Request of Class II Permissive Change

Company name: Harman International Industries, Inc.

FCC ID: APIJBLXTREME3G

This is to request a Class II Permissive Change for FCC ID: APIJBLXTREME3G originally granted on 08/19/2020, due to battery cell and AC adapter added.

Adapter:

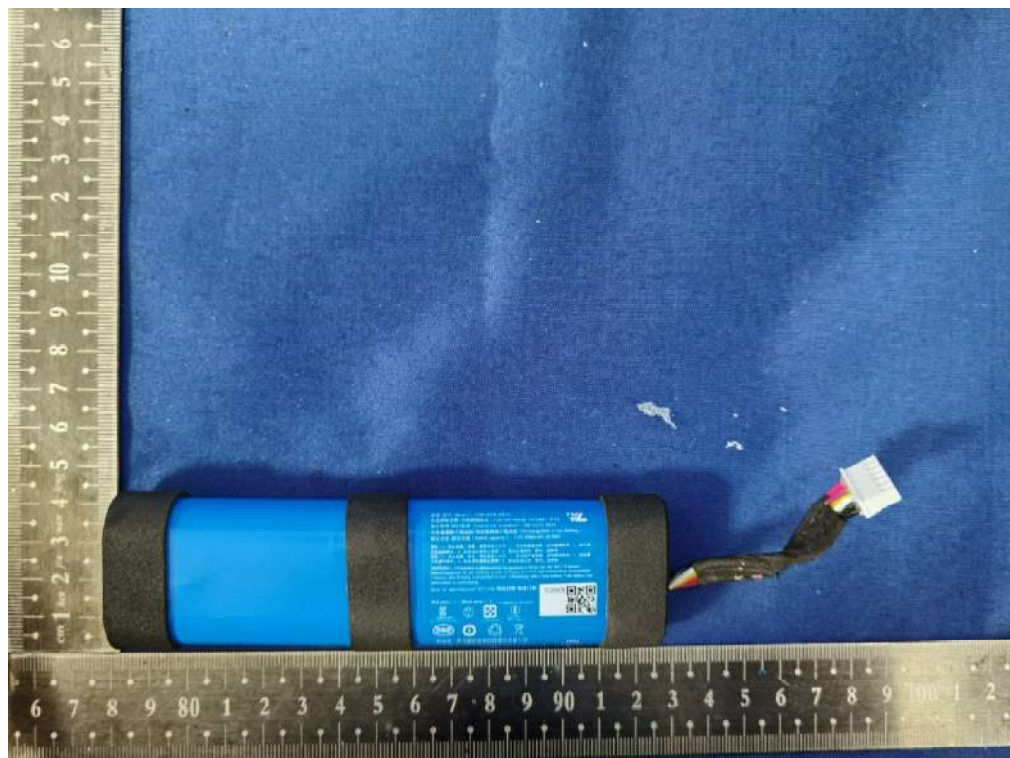
Adapter		Manufacture	Model	Description
	Original	Group Intellect Power Technology Limited	GHWM-PD60W-WC	Input: 100-240V ~ 50/60 Hz 1.5A Output: 5.0V === 3.0A, 9.0V ===3.0A, 12.0V ---3.0A, 15.0V ---3.0A, 20.0V ===3.0A
	New	Shenzhen JingQuanHua & Everrise Intelligent Electric Co., Ltd	NSA60EU-200 3000	Input: 100-240V ~ 50/60 Hz 1.5A Output: 5.0V === 3.0A, 9.0V ===3.0A, 12.0V ---3.0A, 15.0V ---3.0A, 20.0V ===3.0A

The newly added battery cell and adapter will affect the performance of AC power-line conducted emissions and radiated emission (below 1 GHz), and C2PC applied for this.
